CITY OF ALBUQUERQUE

**Re: McDonalds - 8315 Montgomery Blvd NE
Tract A-1-F of the Los Pastores Shopping Center
Grading and Drainage Plan - Engineer's Stamp dated: missing (F19D013A)**

Based on the application received 6/18/2018, the above referenced plan cannot be approved for building permit until the following comments are addressed.

GRADING PLAN

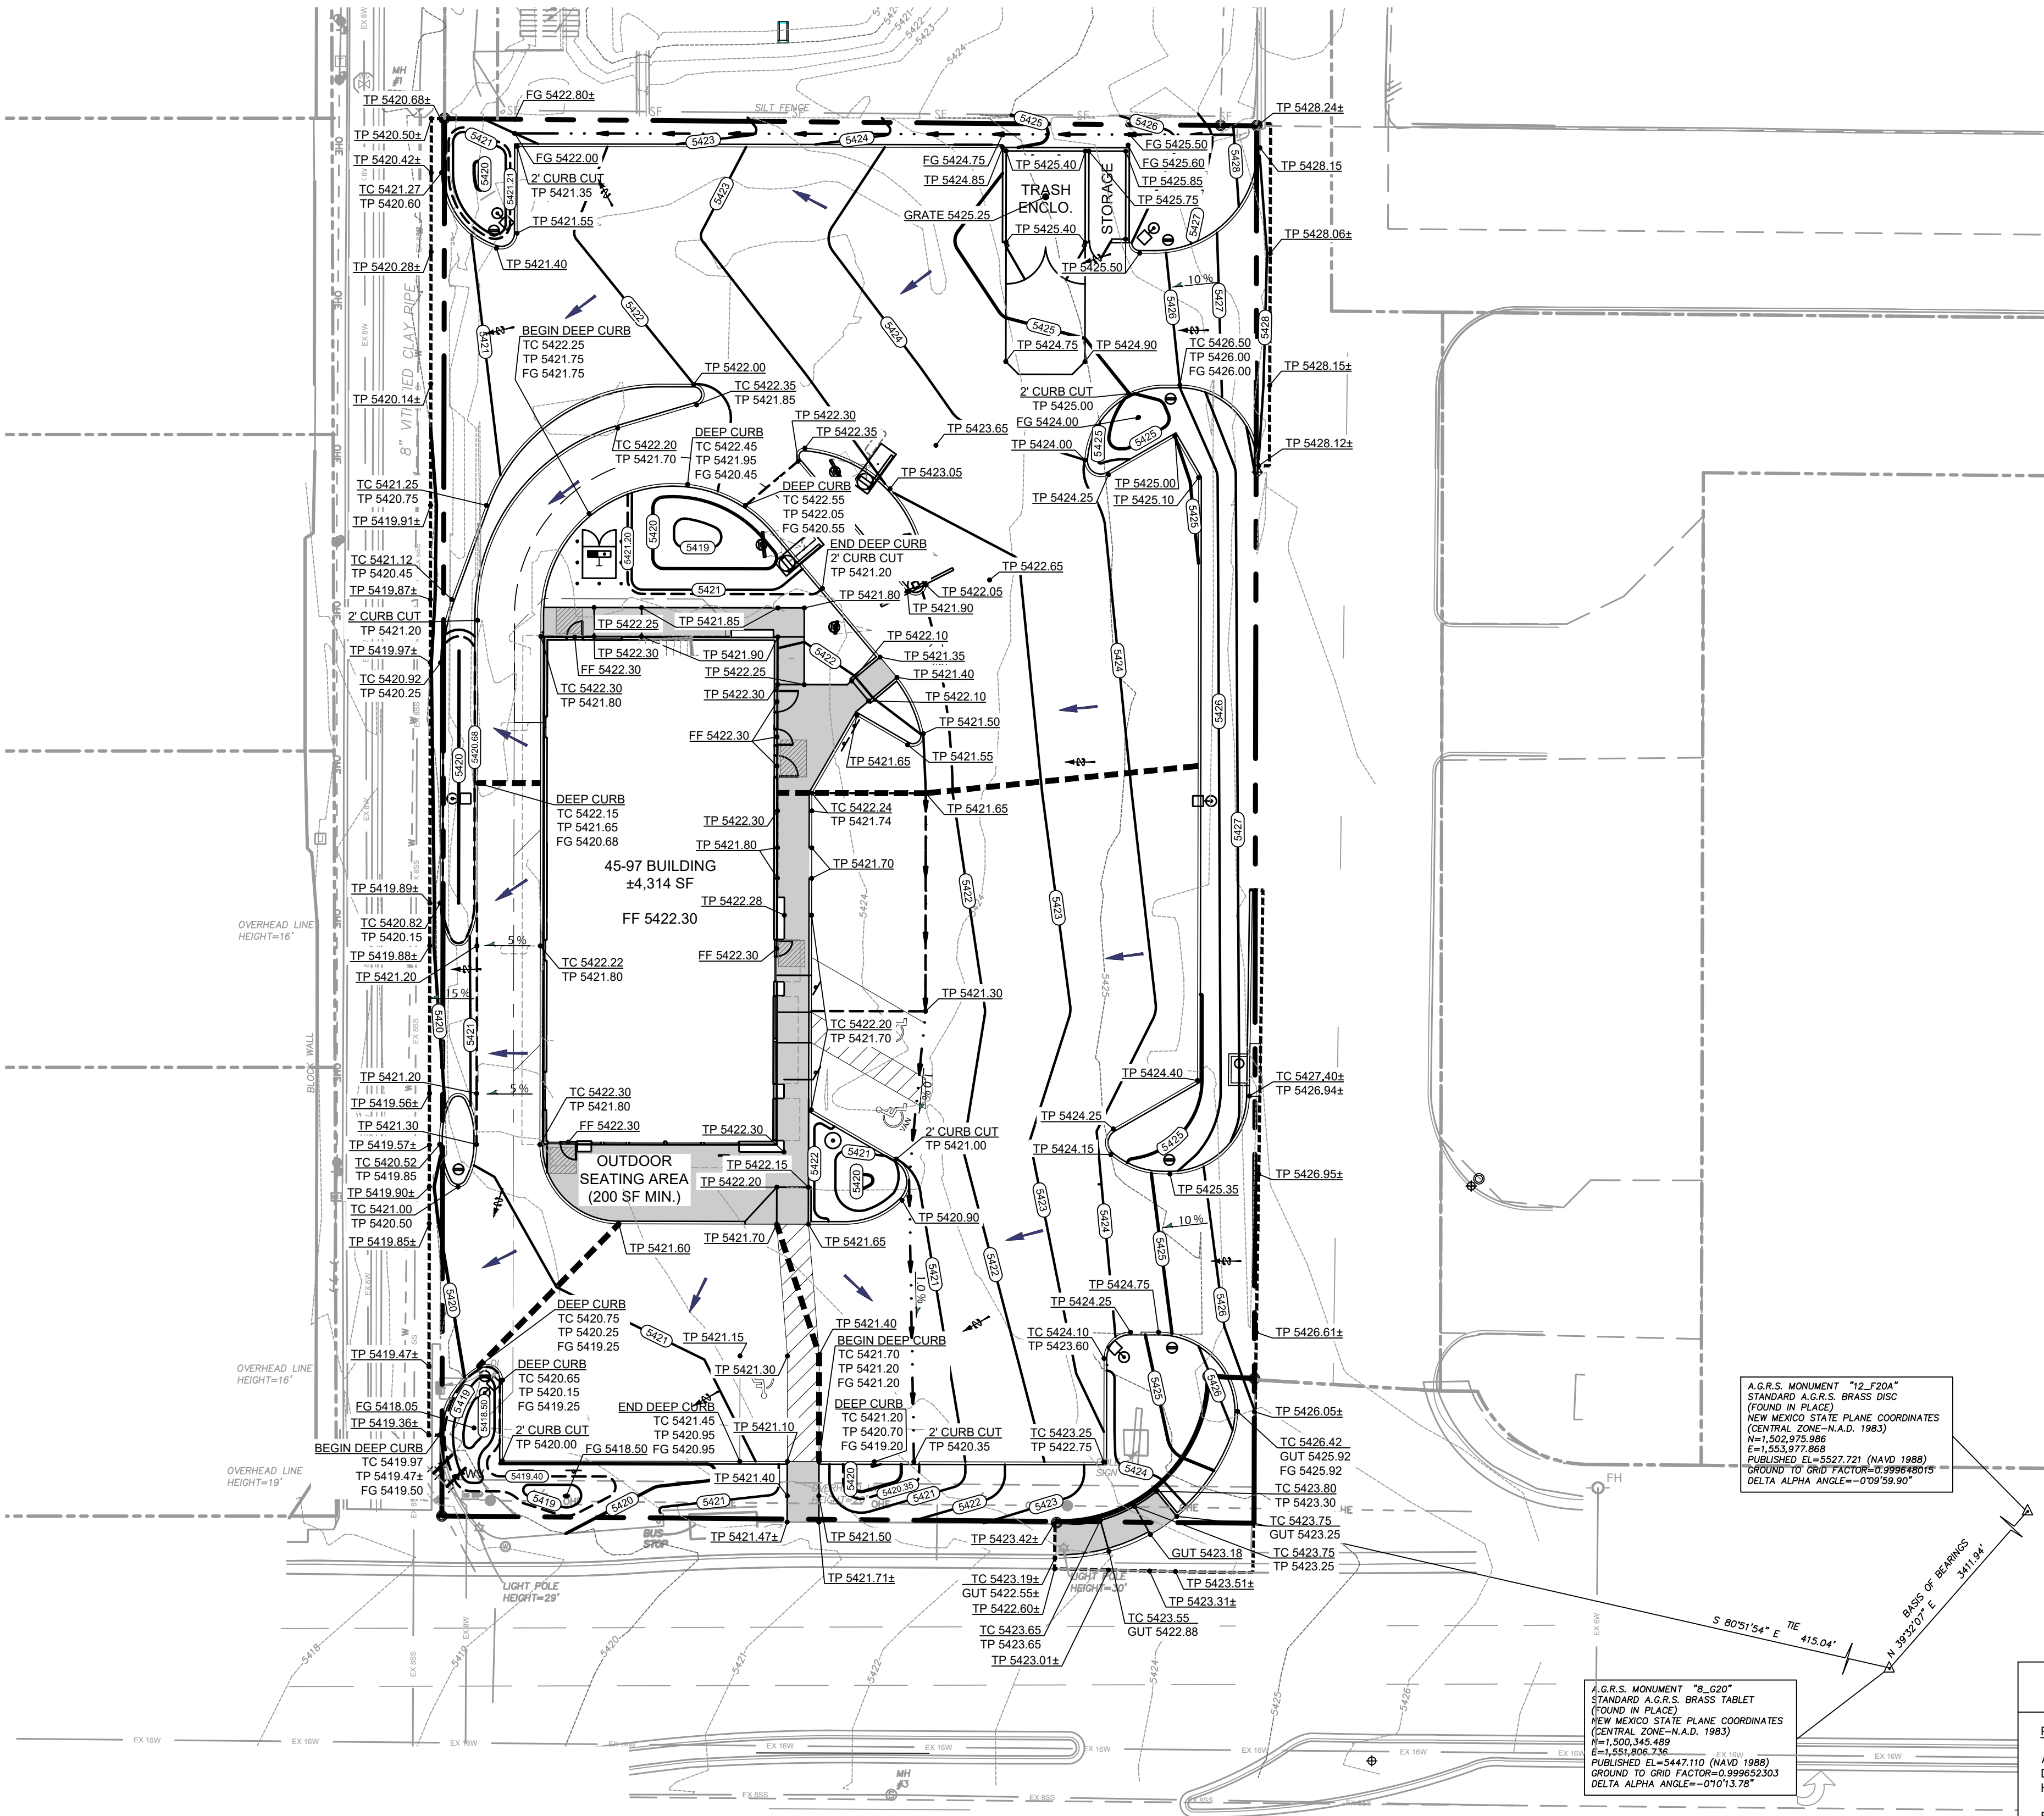
13. Details of all drainage structures must be shown on the plan including pond spillways, curbs, curb cuts, inlets, headwalls, and sidewalk culverts. Hydraulic capacity calculations are required for all inlet, curb cuts, curbs carrying drainage, and pond spillways. Both the first flush elevation and the 100 year elevation must be identified for all ponds. Storm drains must be shown on the Grading sheet 7.0 including pipe sizes and material.
